DATE: October 3, 1975Service Bulletin No. 385C
(Supersedes Service Bulletin No. 385B)
Engineering Aspects are
FAA (DEER) Approved**SUBJECT:** Oil Pump Impeller and Drive Replacement**MODELS AFFECTED AND TIME OF COMPLIANCE:** See chart on page 3.

Supplement No. 1
to Service Bulletin No. 385C

Figure 1. Interior View of Accessory Housing Showing Location of Cotter Pin in Oil Pump Idler Shaft

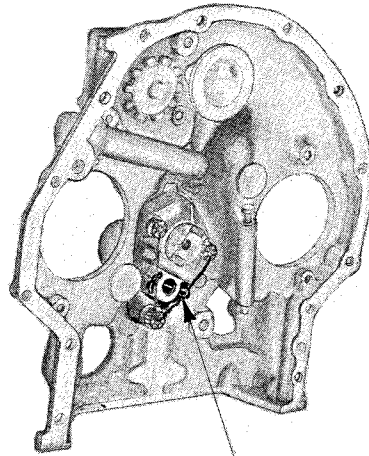
INSPECTION: Applicable remanufactured engines shipped after December 21, 1972 should be inspected to determine if this modification is required: first of all, if the engine log book indicates the engine has not been modified in accordance with Service Instruction No. 1230 or No. 1272, proceed to remove the accessory drive cover from the mounting pad at the lower right side of the accessory housing to obtain access to the area between the crankcase and the accessory housing. On some engines this accessory drive pad is not machined, in this event it will be necessary to remove either the left magneto or the *fuel pump to obtain access to the area between the crankcase and the accessory housing. Regardless of which accessory pad is used, determine if the oil pump idler gear is secured with a cotter pin at the location shown in figure 1. This can be accomplished using an inspection mirror, preferably an illuminated one. If the cotter pin is visible, it is unnecessary to perform the modification required by this bulletin.

IF IDLER SHAFT IS SECURED WITH A COTTER PIN AT THIS LOCATION MODIFICATION IS NOT REQUIRED

Figure 2. Oil Pump Drive Assembly

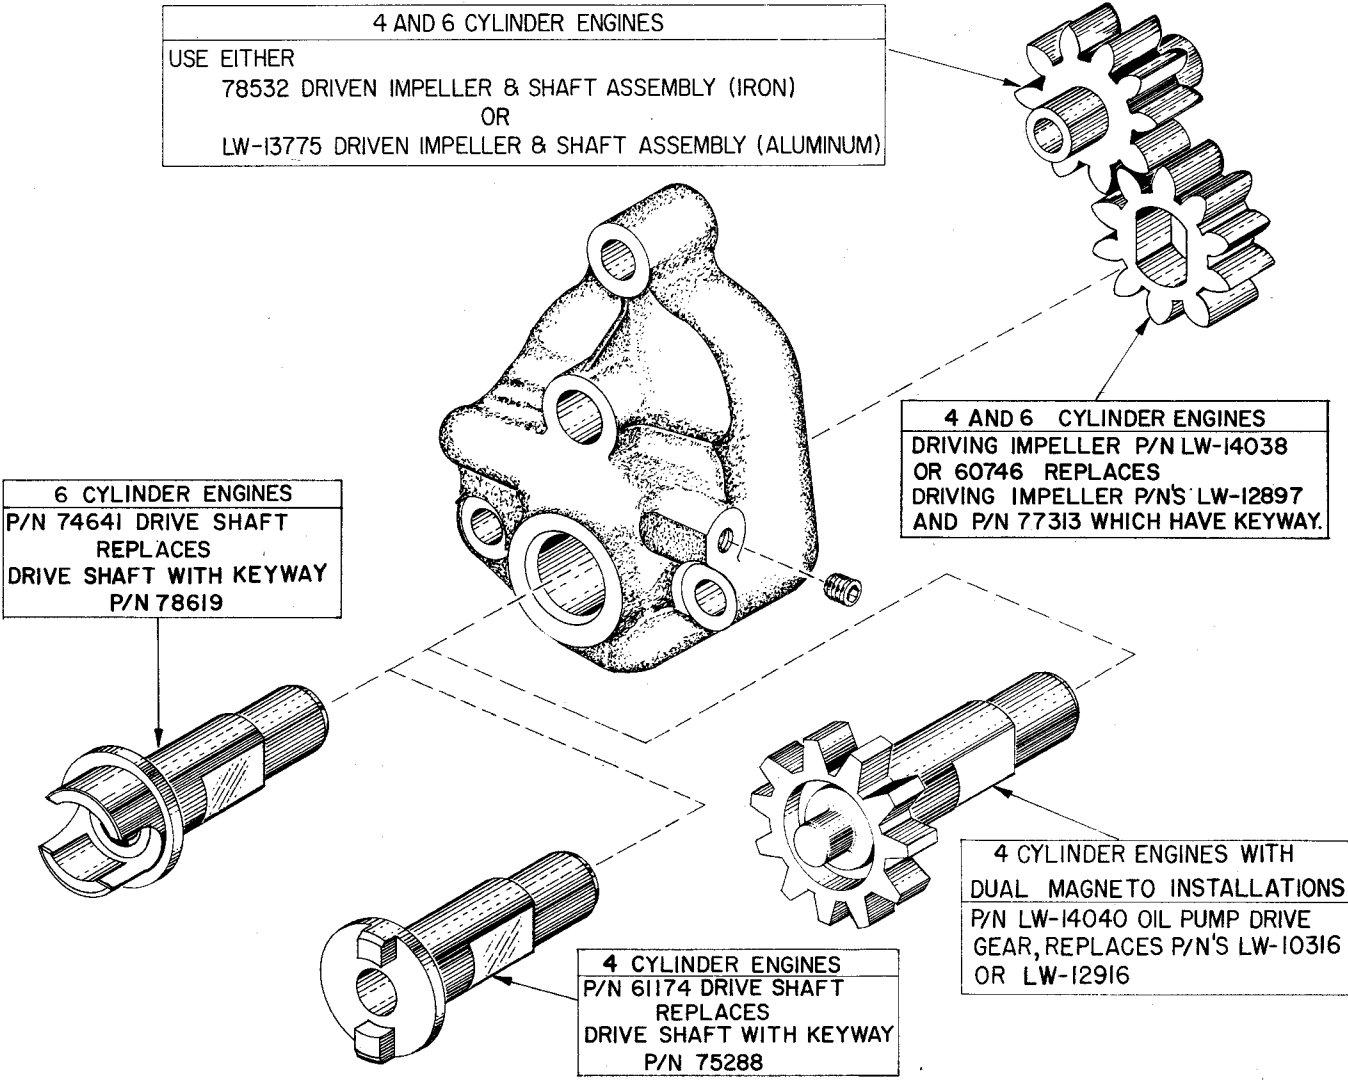
This modification consists of replacing the oil pump drive shaft and drive impeller to eliminate the Woodruff key drive which has proven to be the cause of excessive wear in the keyway of the hardened drive impeller. Therefore, it is recommended that all of the applicable engines listed in the chart, as well as any others that may have been modified in accordance with Service Instruction No. 1272, use the following procedure for parts replacement.

3. Reassemble the oil pump using the new drive shaft and drive impeller supplied with the kits shown in the following "Parts Data" section. See figure 2. Be sure all of the parts are lubricated thoroughly during assembly.

- LW-14131 Oil Pump Shaft Replacement Kit (4 cylinder engines)
 consists of: (1) 61174 oil pump drive shaft, (1) LW-14038 or 60746 drive impeller

- LW-14132 Oil Pump Shaft Replacement Kit (4 cylinder, dual drive magneto engines)
 consists of: (1) LW-14040 oil pump drive gear, (1) LW-14038 or 60746 drive impeller

- LW-14133 Oil Pump Shaft Replacement Kit (6 cylinder engines)
 consists of: (1) 74641 oil pump drive shaft, (1) LW-14038 or 60746 drive impeller
